Access Compliance Report Public Rights-of-Way (Curb Ramps)

Intersection ID: 10021845 Main Street: BRIXHAM_HILL_AV Cross Street: N/A Location: SE

ADA ID: 318B15CA814F Ramp Type: Perp Initial Pass/Fail: Fail Overall Compliance: No Severity Score: 1.25

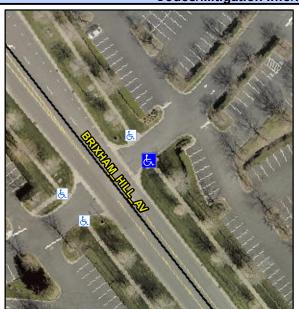
NOT Found, R304.5.3

Field Measurements/Component Compliance					
Compliance Description		Data	Comp	liance Description	Data
N/A	Ramp Length (in)	60.0	Yes	Ramp Slope (%)	5.8
Yes	Ramp Width (in)	49.5	No	Ramp XSlope (%)	2.9
N/A	Flare Type LT	N/A	N/A	Flare Type RT	N/A
N/A	Flare Slope LT (%)	N/A	N/A	Flare Slope RT (%)	N/A
N/A	Flare Traversable LT?	N/A	N/A	Flare Traversable RT?	N/A
N/A	Landing Length (in)	N/A	N/A	DWS Provided?	N/A
N/A	Landing Width (in)	N/A	N/A	DWS Contrast?	N/A
N/A	Landing Slope (%)	N/A	N/A	DWS Length (in)	N/A
N/A	Landing X Slope (%)	N/A	N/A	DWS Full Width?	N/A
N/A	Landing Curb? (Y/N)	N/A	N/A	DWS Offset (in)	N/A
N/A	Shared Landing?	N/A			
N/A	Gutter Ponding?	N/A	N/A	Gutter Slope (%)	N/A
N/A	Gutter Lip Ht (in)	N/A	N/A	Gutter X Slope (%)	N/A
N/A	Painted X Walk1?	No	N/A	Painted X Walk2?	N/A
	X Walk 1 Direction	To NW		X Walk 2 Direction	N/A
N/A	X Walk 1 Width (in)	N/A	N/A	X Walk 2 Width (in)	N/A
	X Walk 1 Slope (%)	2.5		X Walk 2 Slope (%)	N/A

Remove & Replace Entire Ramp.
